Planning Approval Consistency Assessment Form

Assessment Name:	Samuel Marsden Road Sewer main – revised underbore alignment and tree removal
Prepared by:	Parklife Metro (PLM)
Prepared for:	Stations, Systems, Trains, Operations and Maintenance (SSTOM) contractors
Assessment number:	PLM CA001
Type of assessment:	Assessment under EP&A Act 1979, Division 5.2
Version:	Draft (Rev 1.0)
Planning approval No. (where relevant):	e.g. SSI 10051
Date required:	February 2026
iCentral number	SM-26-00013605

2. Description of proposed change which is the subject of this assessment

Figure A1 Location of works area and construction method (As approved under SSTOM ER003 Environmental Review - Orchard Hills Station Sewer Main Lansdowne and Samuel Marsden Roads (dated 29 April 2024)).

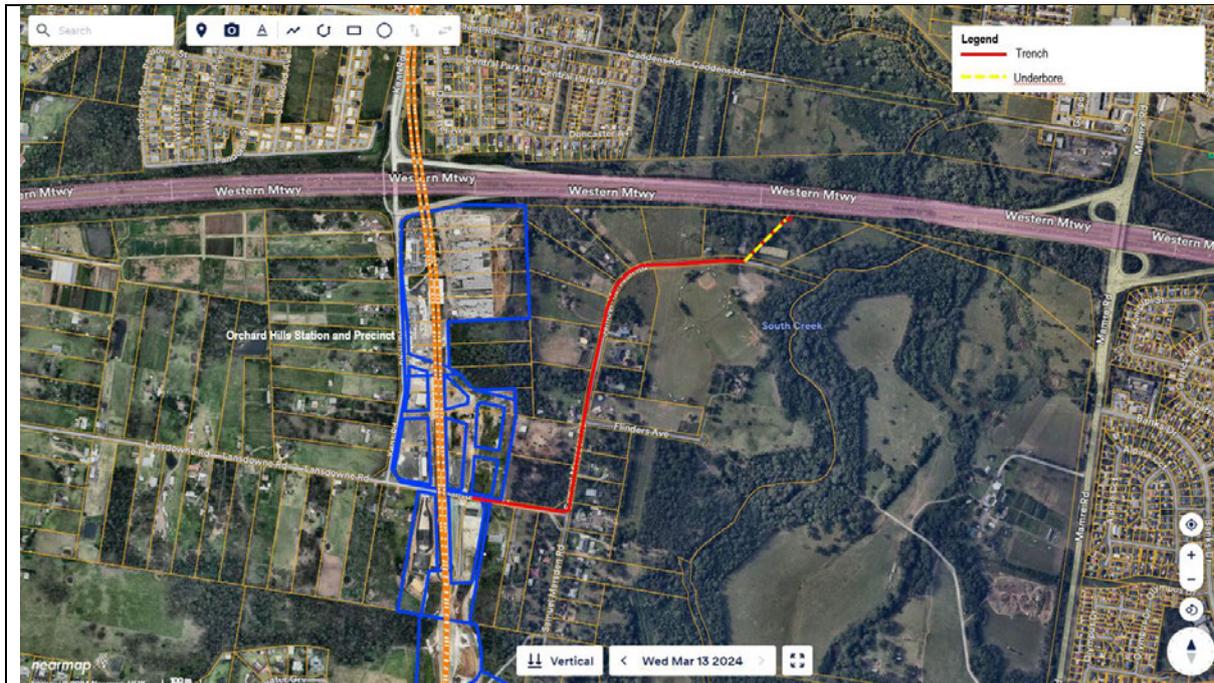
Detailed site survey of the approved sewer main underbore alignment and entry and exit pit locations identified impacts to vegetation which were not assessed in the approved Environmental Review (SSTOM ER003). Figure A3 shows vegetation impact areas at the underbore entry pit (at the end of Samuel Marsden Road) and exit pit (adjacent to the existing Sydney Water sewer submain main at the M4).

Figure A2 Connection to existing Sydney Water sewer submain. (As approved under SSTOM ER003 Environmental Review - Orchard Hills Station Sewer Main Lansdowne and Samuel Marsden Roads (dated 29 April 2024))

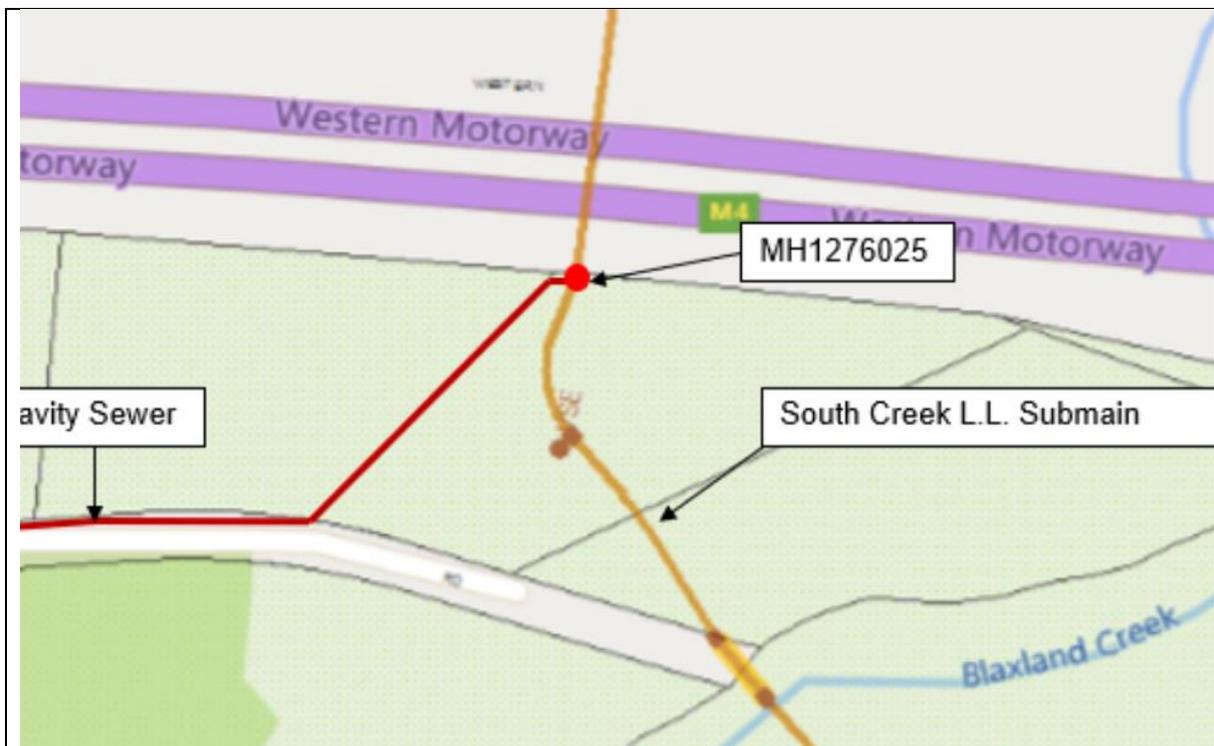
- A design option was proposed to connect the new sewer main directly to the Sydney Water sub-main. This option involved adjusting the connecting directly to the existing 1350mm sewer sub-main by constructing the maintenance hole directly over the sub-main. This option was found to present significant complexity for both design and construction. Direct connection to the active sewer main would require a detailed flow management strategy to initially inform design and then a high level of flow management during construction in comparison to a breakthrough connection to an existing maintenance hole. In addition, the size of the existing carrier main would require a custom maintenance hole design, requiring specialist engineering input and multiple non-standard review stages with Sydney Water. The WSC has advised this options would be unacceptable to Sydney Water and progressing this options would also create a risk to the construction program. This option has been discounted. The location of the maintenance hole has been retained. Tree removal at MH19 is required.

Figure A4 Samuel Marsden Road – Cabbage Gums (vegetation avoided my maintenance hole / underbore entry pit relocation)

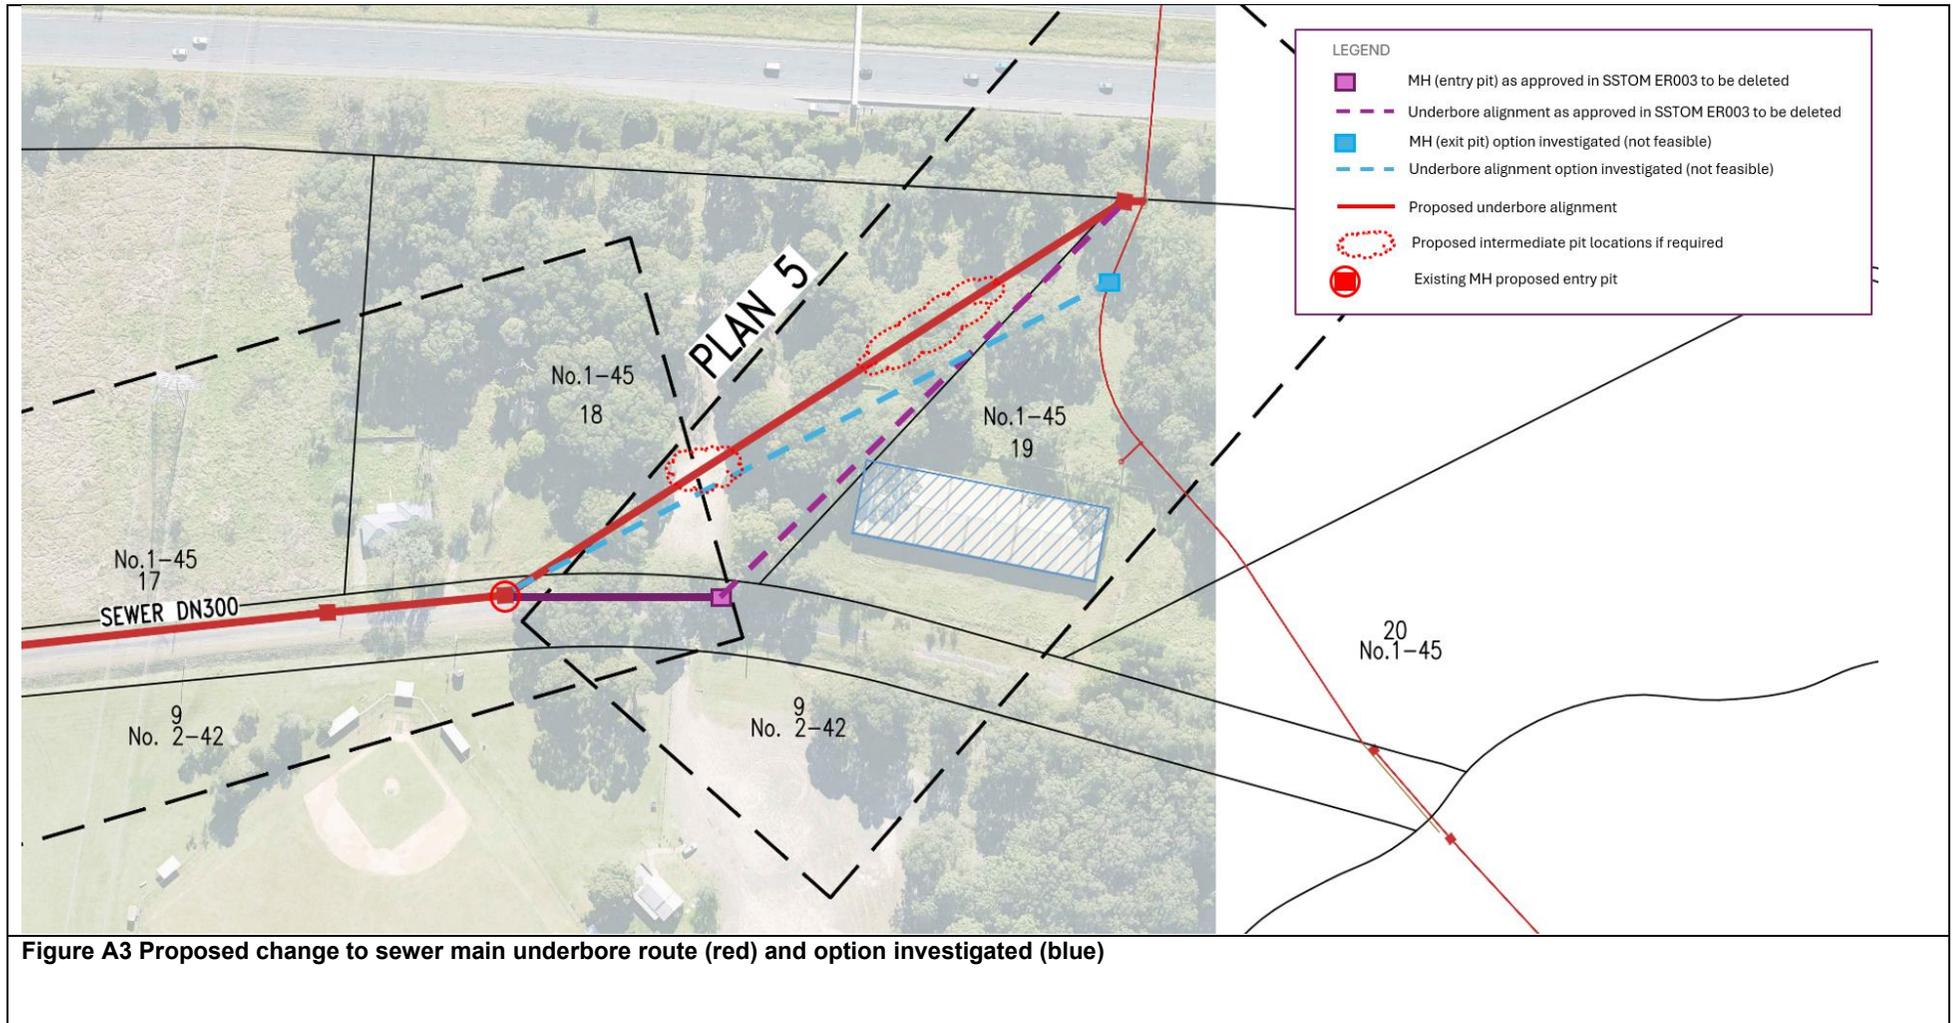
This Consistency Assessment relates to a new proposed underbore alignment between Samuel Marsden Road to the existing Sydney Water submain sewer main to minimise tree removal. The new alignment:

- Removes one maintenance hole on Samuel Marsden Road
- Relocates the underbore entry pit, reducing the length of trenching along Samuel Marsden Road by approximately 55m.
- Requires removal of two trees to allow connection to the existing Sydney Water sewer sub-main.
- Provides allowance for an intermediate pit/s along the underbore alignment in locations where vegetation removal is not required.
- Requires geotechnical testing prior to construction to confirm subsurface conditions and detailed construction methodology.

- The final maintenance hole on Samuel Marsden Road was removed and the trenched portion of sewer main shortened by approximately 55m to commence the underbore at the previous maintenance hole. This design change eliminates potential tree removals along Samuel Marsden Road and situates the underbore entry pit in an area which avoids tree removals. Damage and impact to trees along Samuel Marsden Road have been avoided by this proposed change.
